MURRAY RIVER COAL PROJECT

Summary of Waste Rock Facility Design Documents

**MURRAY RIVER BULK SAMPLE
Waste Discharge Permit Application
Technical Assessment Report and
Notice of Work Addendum:
Comments and Responses**

SUBJECT: Waste Rock Facility Stability Assessment – Use of Geomembrane Instead of Clay Liner

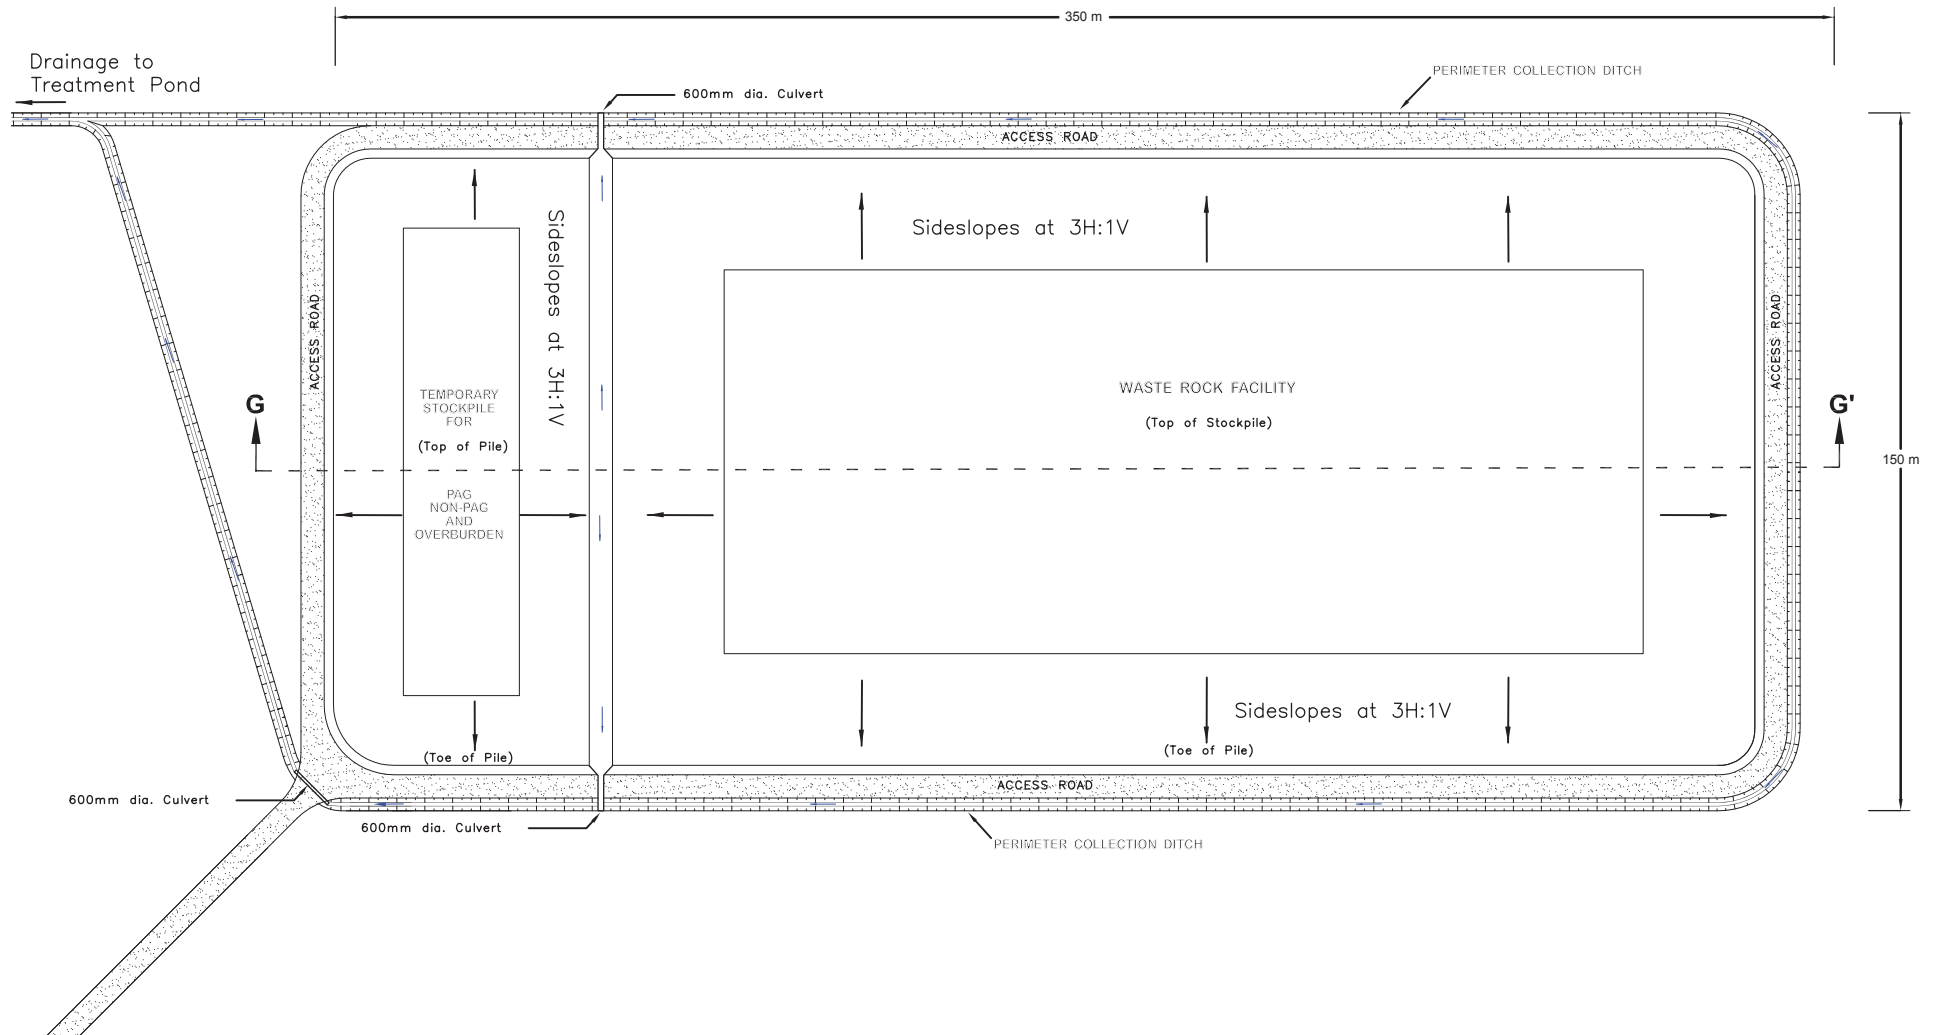
- h. There is a discrepancy between dimensions quoted in the text of the TAR (page 6-3) and those shown on the plan view schematic (Figure 6.2-3). Please correct this in the detailed designs.
- i. MEM strongly recommends that consideration be given to the ability to move waste rock into the underground if this project proceeds to full-scale mine development in the future.

Site Preparation

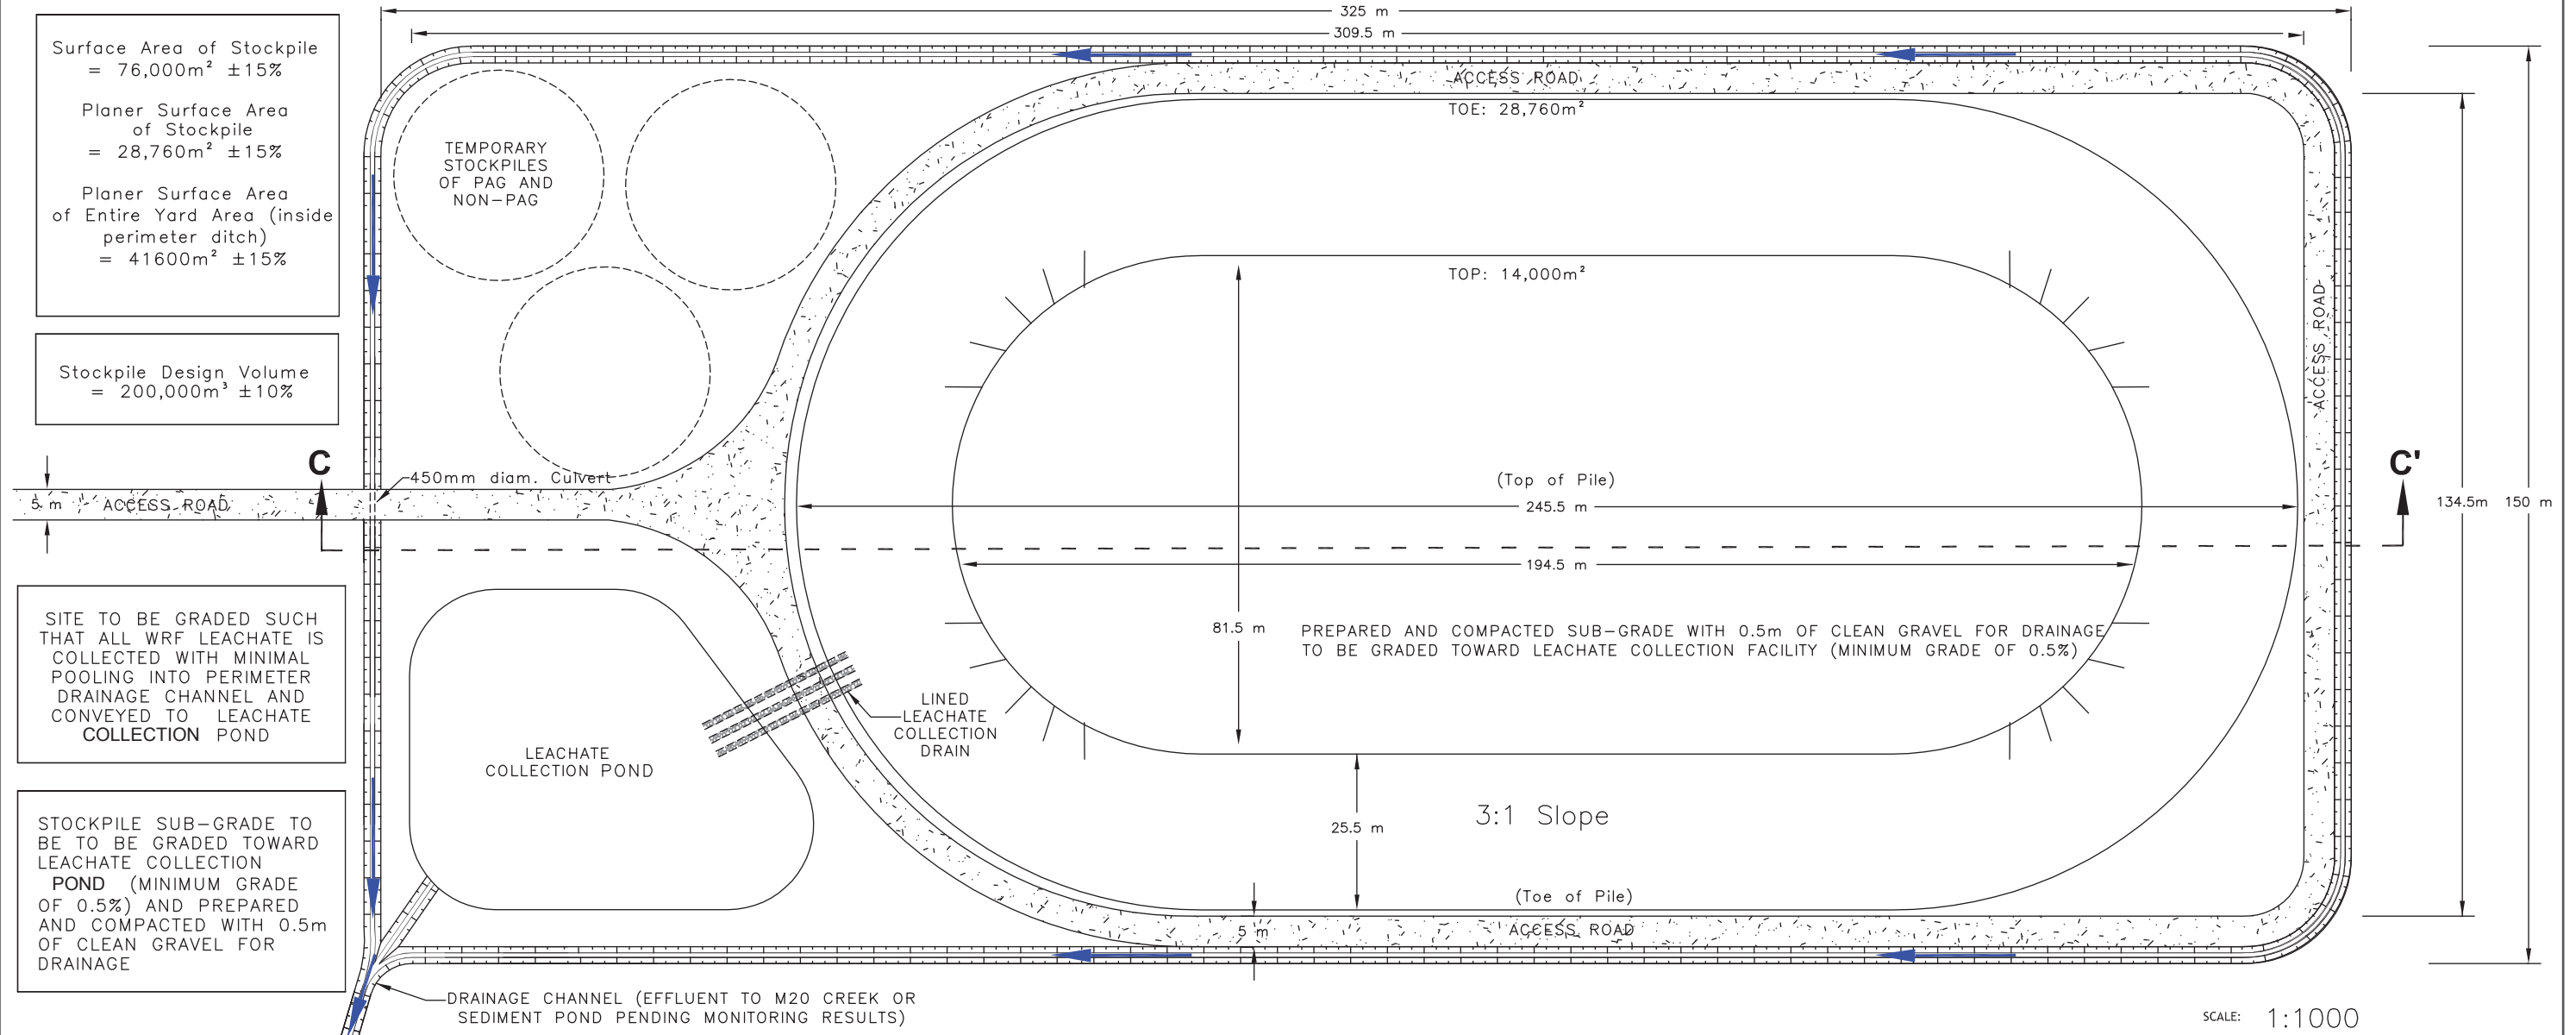
- f. Section 6.2.3 describes subgrade preparation. Details should be provided to describe design for contouring of subgrade to ensure the waste rock dump may be constructed in a manner that prevents water from ponding beneath the dump.

Clearing and grubbing entails the removal of all timber and vegetative material from the WRF footprint area (approximately 325 m X 150 m). Unusable timber, slash, and vegetative debris will be cleared and pushed into stockpiles along the perimeter of the footprint to be used to create micro-habitats for wildlife during future reclamation. The topsoil (A and B soil horizons) will be salvaged from WRF footprint area and stockpiled. It is estimated that up to 50 cm or 26,000 m³ of topsoil can be salvaged from the WRF footprint. Living plant fragments and seeds contained in the soil's seed bank will regenerate once the soils are applied to the reclamation site and will assist with re-vegetation efforts. Stumps, unusable timber, and other small woody debris will be placed along the perimeter of the cleared footprint area to be used to create substrate diversity during future reclamation. Any loose surface till will also be salvaged and stockpiled for later use. The WRF footprint will be graded and contoured (nominal 1% slopes) so that any drainage of water from beneath the waste rock and foundation liner system will report to the perimeter collection ditches.

Once contouring is complete, the native material will be compacted. Accepted industry standards for compaction will be followed. Through soil sampling and laboratory testing, HD will determine the optimum compaction density (ASTM D1557 - Proctor Density) and moisture content for the native material. HD will also conduct an investigation, both on-site and off-site, to determine a source of usable clay material.
